Instrument Cluster Reprogramming (MID 140) GU, GR

PI0889 Differential Lock Engagement Status Alarm Update (MID 140)

(March 2020)

Granite (GR)

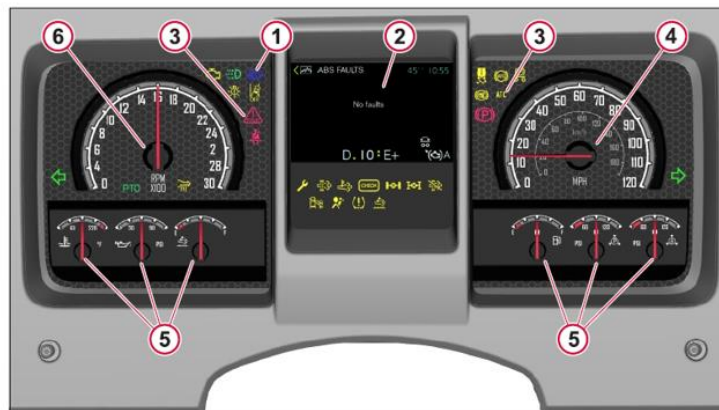
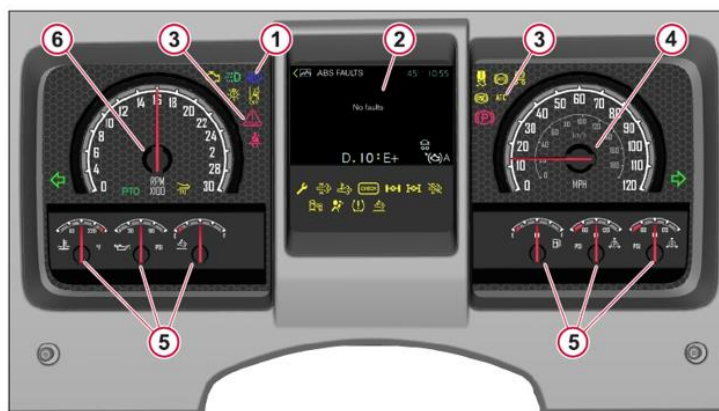
This notification is to announce that Mack trucks has released improved differential lock warning software for the instrument cluster. Previously the driver would be initially alerted to the system engagement with a popup in the cluster along with an audible alarm that lasted approximately five seconds then would automatically dismiss. The improved software keeps the message and alarm persistent until the system is disengaged. The message in the cluster can be ignored for thirty seconds but will return. The following highlights the differences between the current and new software. To perform the update, follow the procedure below

Current Software

Diff-Lock Engaged: (Popup + audible + Icon) Begins

Popup = 30sec

Audible = 5sec

Icon = Continuous

New software

Diff-Lock Engaged: (Popup + audible + Icon) begins

Popup = Continuous, but can be dismissed.
If dismissed will return > 30sec

Audible = follows popup

Icon = continuous
